SERVICE LETTER #47

SUBJECT: Rudder Pedal Torque Tube Cracking

APPLICABILITY: Kitfox Models 1 through 4, Classic 4

Figure 3 - Torque Tube Inspection

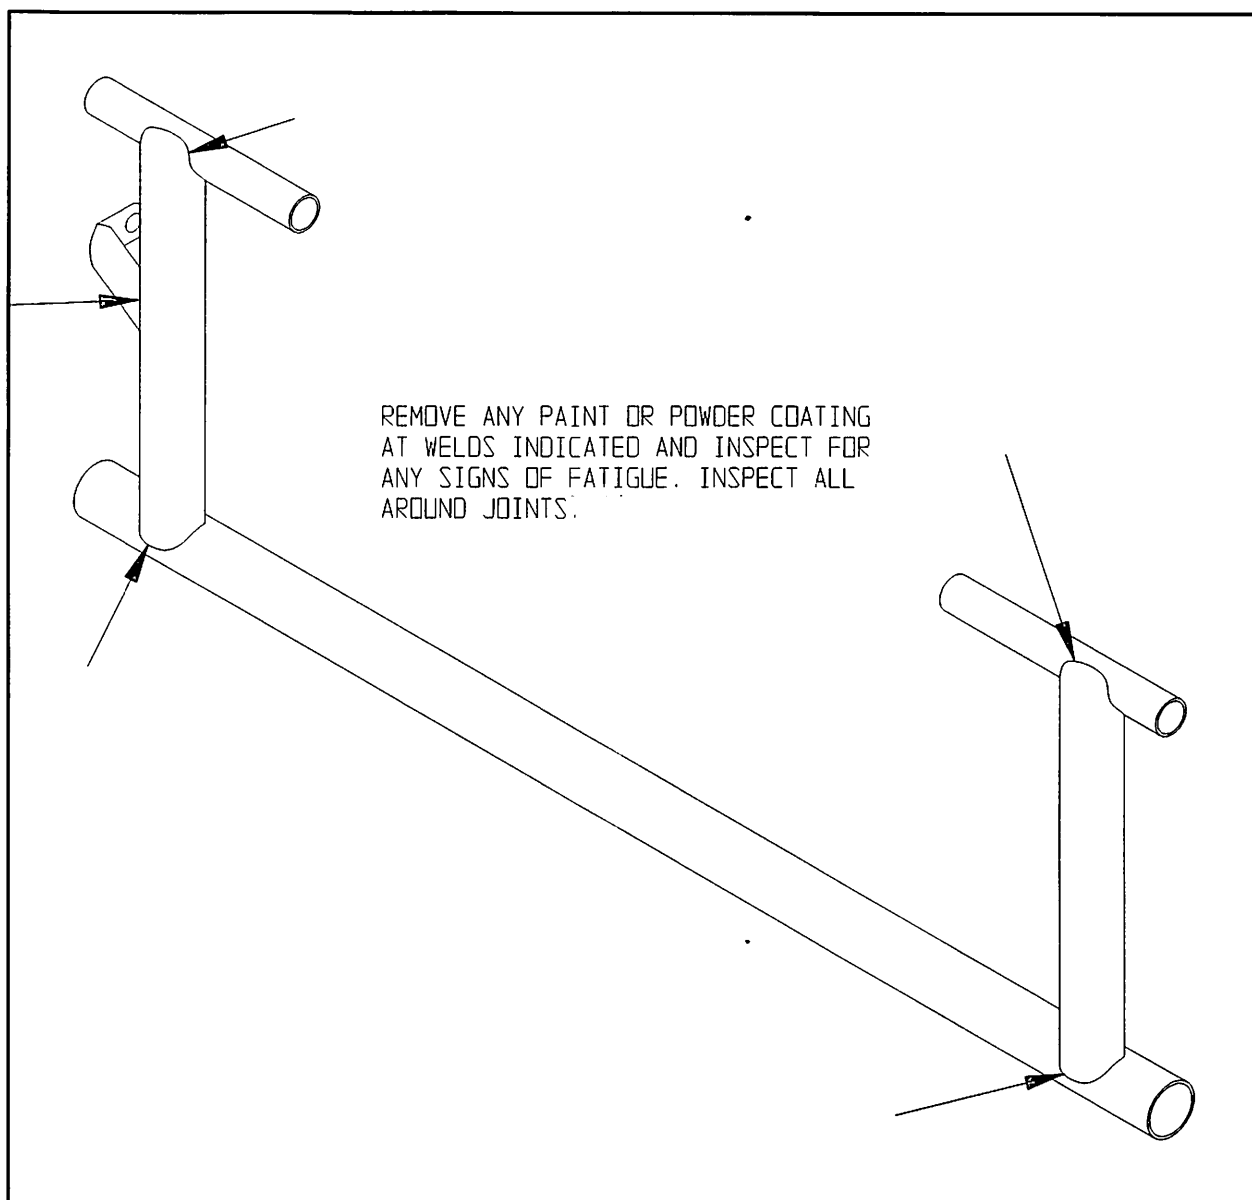
We have recently noticed that some of the rudder pedal torque tubes in our older factory aircraft have started showing signs of fatigue at the positions shown in Figure 1. Because of this we recommend that each owner/builder inspect his torque tubes carefully for any signs of fatigue or cracking prior to the next flight of the aircraft. You should remove the assembly from the aircraft so it may be inspected under more optimal conditions. Prior to inspecting the areas indicated, remove any paint or powder coating around the welded joints with a piece of emery paper. If no cracks are seen, repaint the areas around the joint with a coat of paint just thick enough to protect the assembly from corrosion and add the tube to your list of items to be inspected on both preflight inspections and annual condition inspections.

If cracks are seen, replace the assembly before flying the aircraft. Even if no cracks are seen, we advise that you install a reinforcement kit on the tubes prior to continuing operation of the aircraft. This kit is part number 35015.000 and may be purchased from SkyStar for \$59.95.
